# SCHWEIZER SERVICE BULLETIN

C1B-012  
12 Mar 2001

SUBJECT: ONE-TIME INSPECTION FOR CONDITION AND MODIFICATION OF CERTAIN IDLER PULLEY SUPPORT ASSEMBLIES

MODELS AFFECTED: ● Model 269C-1 Helicopters S/N S0104 thru 0117, S0119 and S0121

Figure C1B-012, Measuring Clearance between Idler Pulley and Spacer

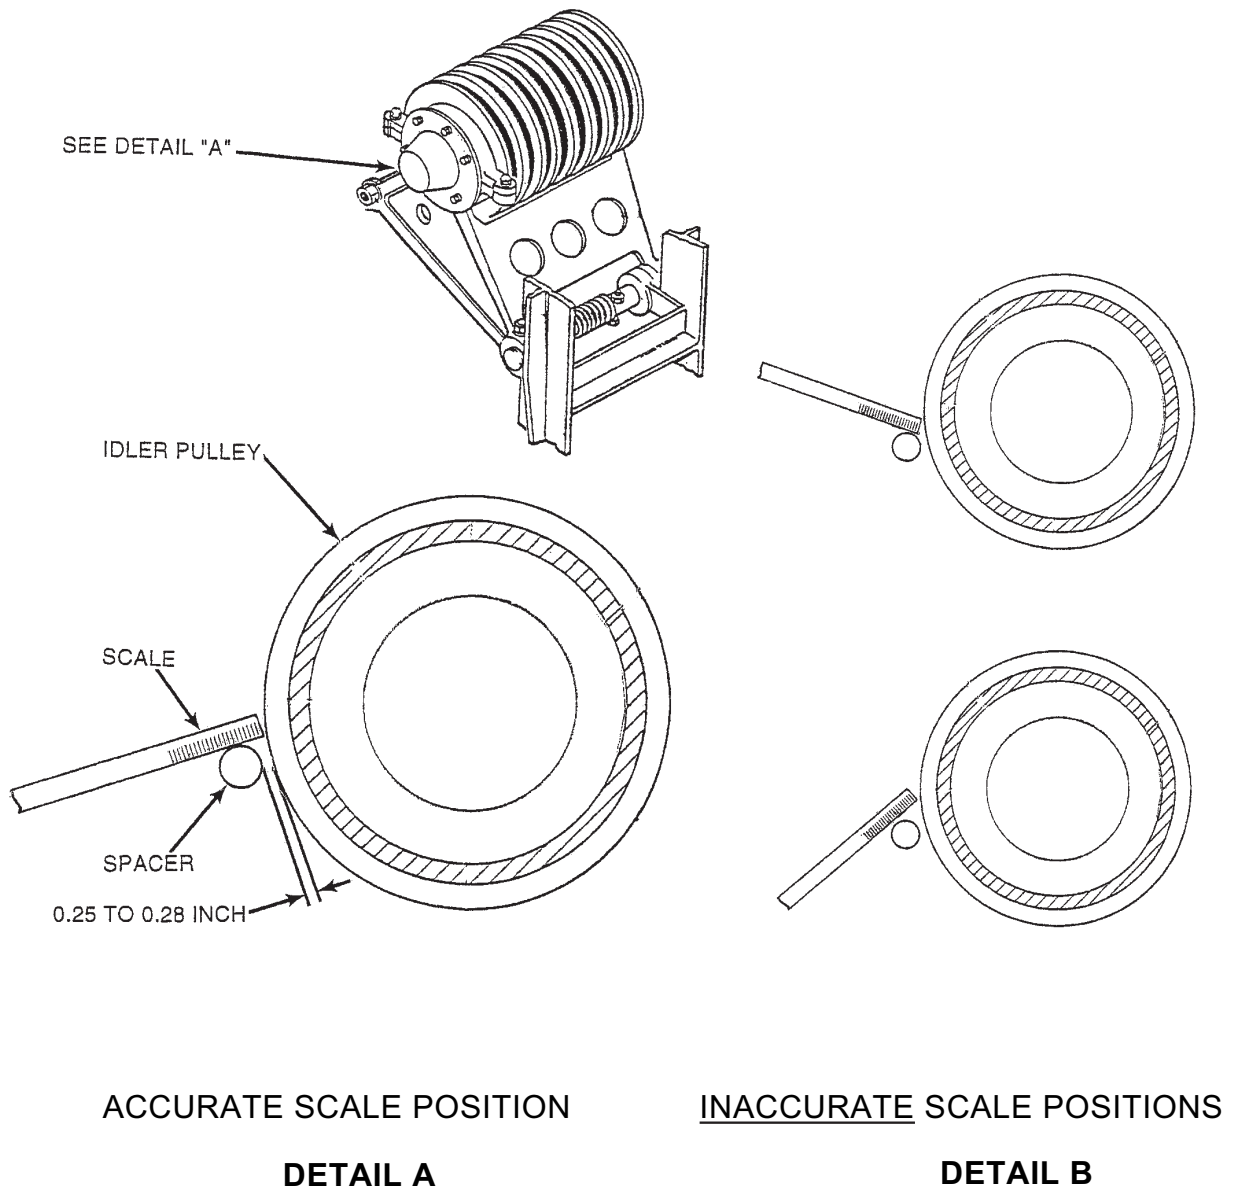
PREFACE: ● When a 269A5575-11 idler pulley support assembly is installed with 269A5437 BSC spacers (0.56 inch diameter) there is excess clearance between the spacers and the clutch drive V-belts. With this condition, the V-belt(s) could possibly jump out of the idler pulley groove(s) with the drive belt clutch disengaged. This Service Bulletin requires replacement of the BSC spacers with 0.75 inch diameter 269A5437-3 spacers which will remove the excess clearance between spacers and V-belts.

In next step, when measuring clearance between outer edge (rim) of idler pulley and spacer, insure that position of scale and angle of sight are correct to measure the distance between the closest points of the two components (Figure C1B-012, Detail A). Unacceptable assemblies measure approximately 0.35 inch between pulley and spacer; **AND** belts can be manually deflected out of pulley grooves.

- (2) Measure distance between outer edge of idler pulley and spacer; it should be approximately 0.25 to 0.28 inch. If this measurement is correct, it verifies that a 269A5575 BSC, -3, -5, -7, or -9 assembly is installed; **OR** that a 269A5575-11 assembly is installed with larger diameter (0.750 inch) 269A5437-11 spacers. In either event, no further action is required; record compliance (step c. below). If measurement is greater than 0.25 to 0.28 inch, proceed to step b.

- b. Remove the 269A5437 BSC spacers and replace with 269A5437-3 spacers using applicable steps of Basic HMI, Section 10. Check measurement specified in step a.(2) above.
- c. Record compliance with this Service Bulletin in the aircraft records.
